# 1120 TRIM SAW DUST COLLECTION UPGRADE

**1120-809C  
VACUUM UPGRADE**

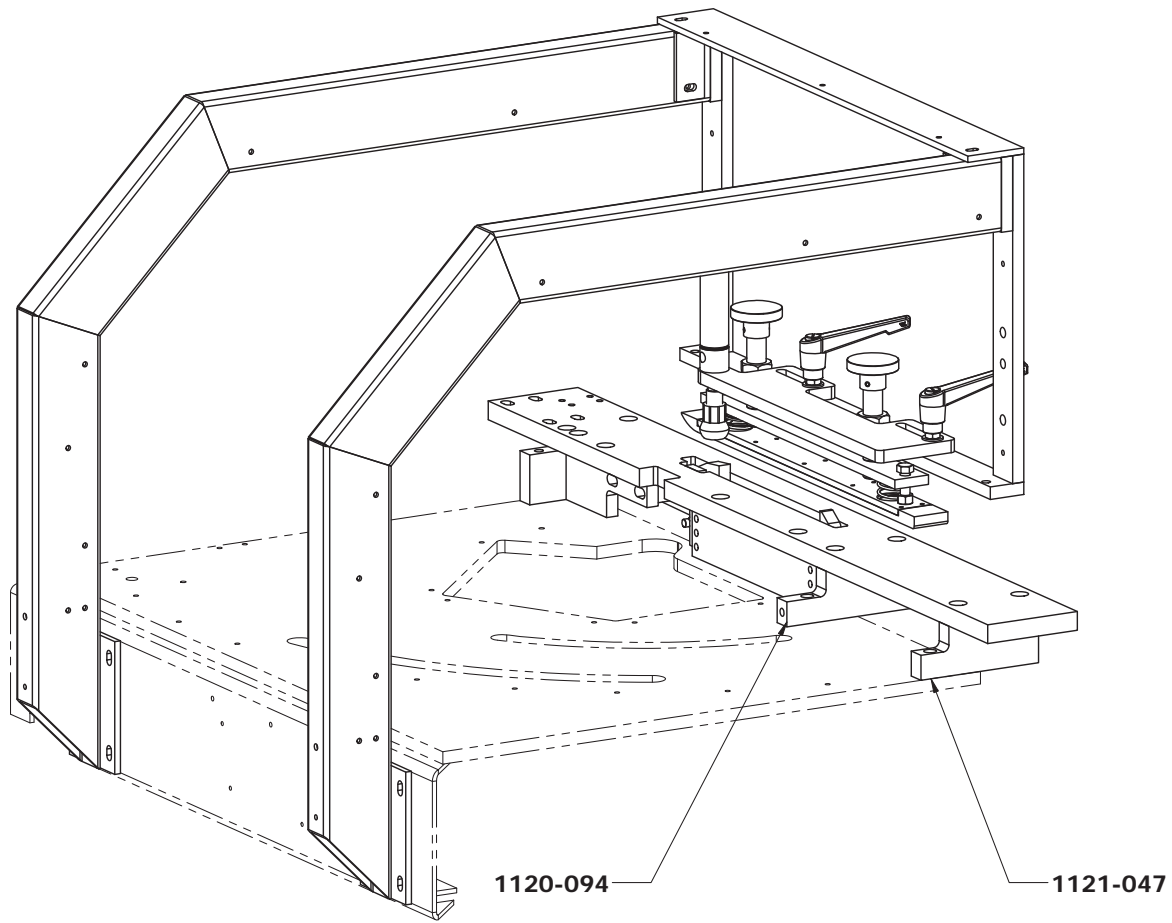
1. Remove the Top Covers from both saw assemblies.
2. Remove the existing Blade Shrouds and install the new ones.
3. Drill and tap the Arbor on each Saw Assembly for mounting the Vacuum Manifolds. (see drawing on next page for hole locations).
4. Mount the Vacuum Manifolds using the bolts and spacers provided.
5. Replace the Support Brackets on both the Movable and Stationary saws (refer to page #4).
6. Drill and tap both aluminum Turntables for mounting the Vacuum Ports. (see drawing on next page for hole locations). Note: this step is not easy - you'll need an angle head drill.

**BEFORE MOUNTING THE VACUUM PORTS (1121-112 & 1121-113) TO THE ALUMINUM TURN-TABLES, REPLACE THE EXISTING SUPPORT BRACKETS WITH THE MODIFIED ONES AS SHOWN ABOVE. THE MOVABLE SAW IS SHOWN FOR REFERENCE - THE STATIONARY SAW USES THE SAME PARTS.**

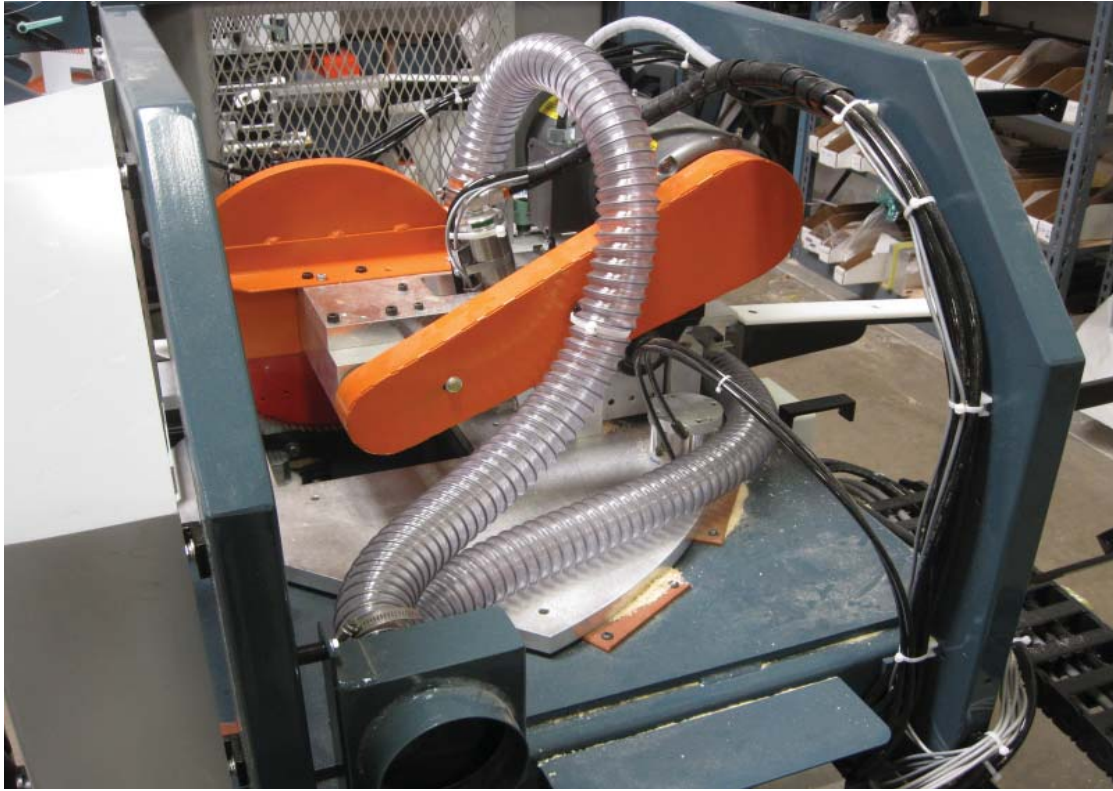
Vacuum Hose Connection  
(Movable Saw)

Vacuum Hose Connection  
(Stationary Saw)
